**URGENT FIELD SAFETY NOTICE****RE: SINGLE USE LIGATING DEVICE POLYLOOP**

Material ID	Model Number	Material Description	Lot Numbers	UDI
N5382130	HX-400U-30	SINGLE USE LIGATING DEVICE POLYLOOP	All Lots	04953170368615

**Attachment 1 - SINGLE USE LIGATING DEVICE HX-400U-30  
Preventing Incorrect and Incomplete Loop**

Figure 1

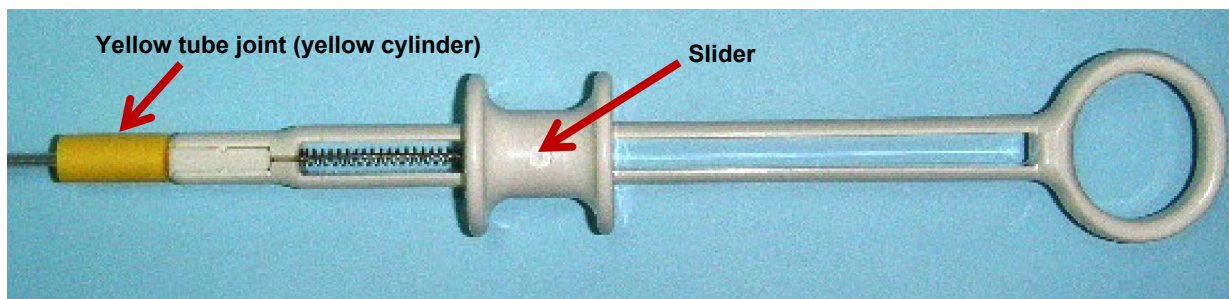
- Inadvertent or intentional movement of the yellow tube joint (cylinder) away from the device handle during use. Intentionally moving the yellow tube joint away from the handle to prematurely tighten the loop during use may cause the inability to release the ligation loop. (See figure 1 below.)

■ **Do not hold the loop with the distal end of the tube sheath while the loop is surrounding the tissue. (refer to page 5 in the manual)**

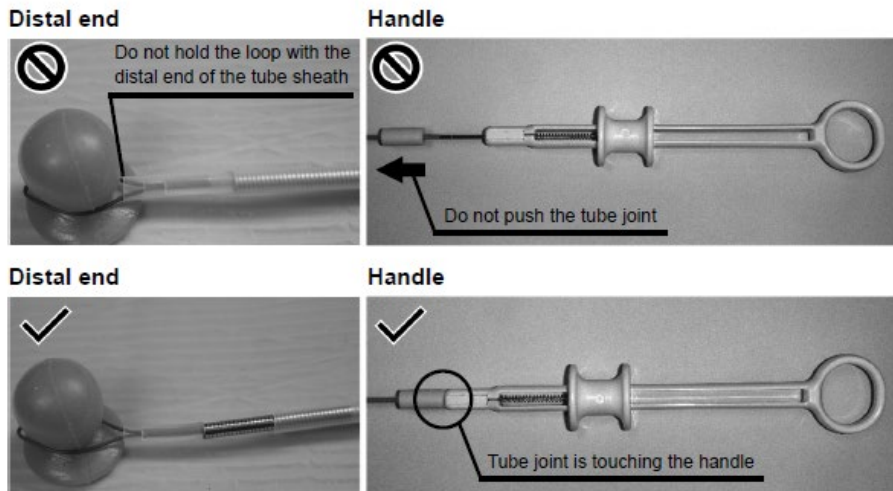
Otherwise, when the tissue is ligated, the loop may be detached from the hook in the tube sheath and tangled with the hook.

- **Do not remove the loop from the hook while the coil sheath is not extended from the tube sheath. (refer to page 6 in the manual)**

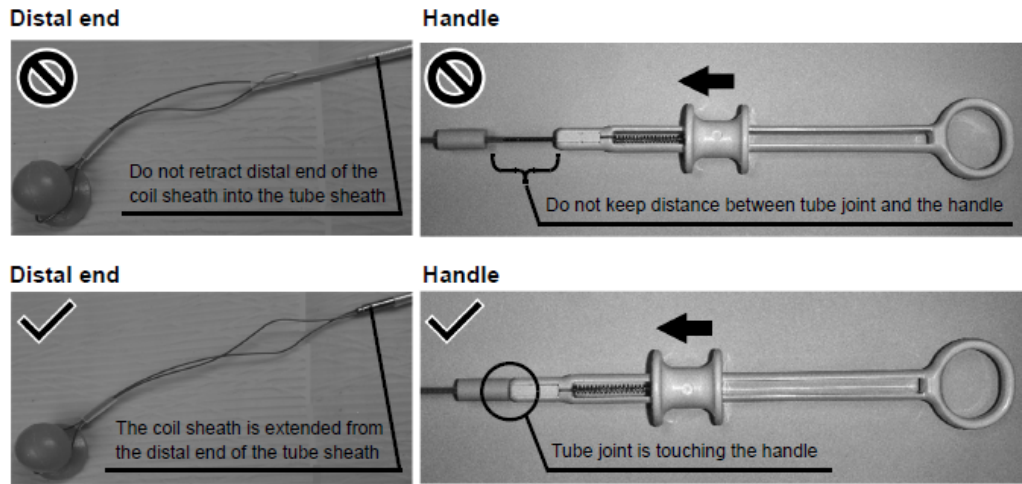
Otherwise, the loop may be tangled with the hook and become impossible to be removed.

- **With the proximal end of the tube sheath and handle kept straight against the biopsy valve of the endoscope, push the slider when detaching the loop. (refer to page 6 in the manual)**

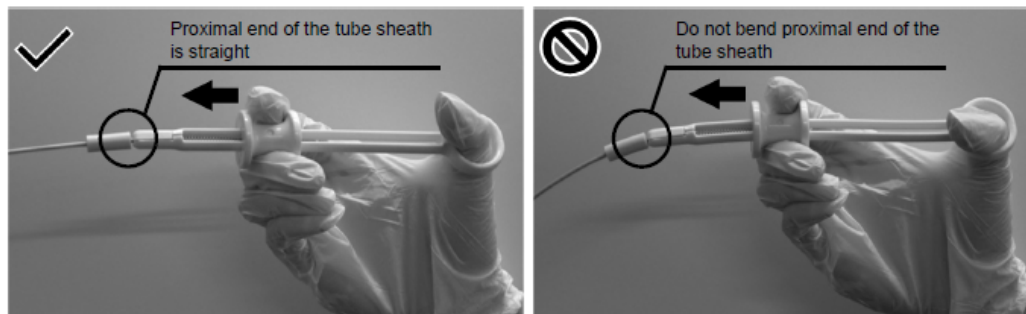
Bending the proximal end of the tube sheath will increase frictional resistance, which may damage the handle when pushing the slider.
